Project	IEEE 802.16 Broadband Wireless Access Working Group < http://ieee802.org/16 >
Title	CR on SDD Section 18: Procedure of Interference Mitigation among multiple cells
Date Submitted	2009-2-24
Source(s)	Honghai Zhang, Linghang Fan, Sampath Rangarajan, Nader Zein, Tetsu Ikeda, Andreas Maeder, Amir Khojastepour, Mohammad Madihian honghai@nec-labs.com NEC
Re:	Change request to Project 802.16m System Description Document (SDD) (IEEE 802.16m-08/003r7)
Abstract	This contribution provides text addition to SDD to facilitate the interference mitigation among multiple cells in SON.
Purpose	For discussion and approval by IEEE 802.16m TG
Notice	<i>This document does not represent the agreed views of the IEEE 802.16 Working Group or any of its subgroups. It represents only the views of the participants listed in the "Source(s)" field above. It is offered as a basis for discussion. It is not binding on the contributor(s), who reserve(s) the right to add, amend or withdraw material contained herein.</i>

Procedure of Interference Mitigation among Multiple Cells

Figure 1 Procedure of Interference Mitigation

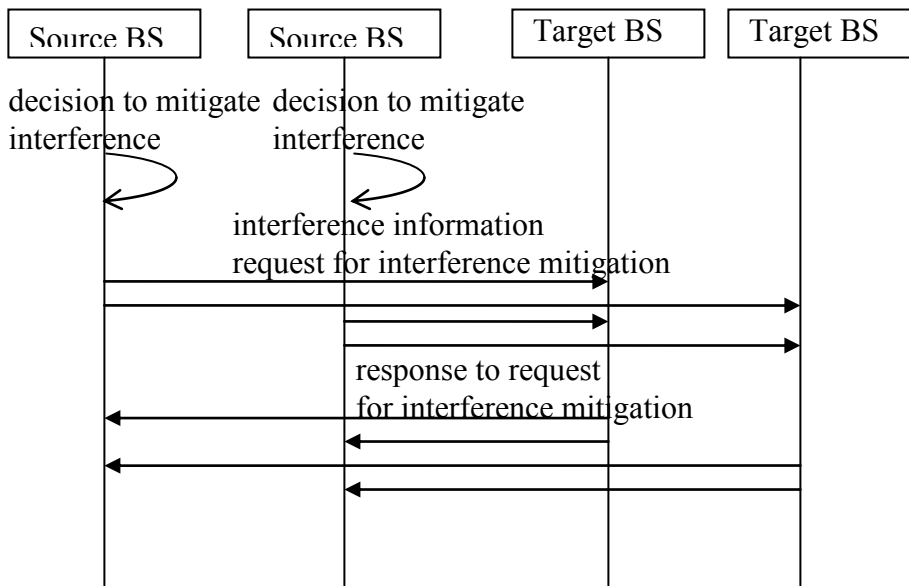
Insert the following text into the “Support for Self-organization” clause (IEEE 802.16m-08/003r7):

Source BSs can continuously monitor its own interference situation, decide to mitigate interference, and then collect interference information and related parameters from the MSs and the neighbor cells. Then the source BS decides which neighbor BSs are the target BSs which need to control its transmission power and sends them the power update request or necessary information to compute appropriate transmission power for interference mitigation. Each target BS receives the requests, analyzes its own interference situation, and decides whether to change its power settings, and sends back the response to the source BSs. After receiving the response or not receiving the response after a pre-specified period, Source BS can continue to send interference mitigation request or cease interference mitigation.
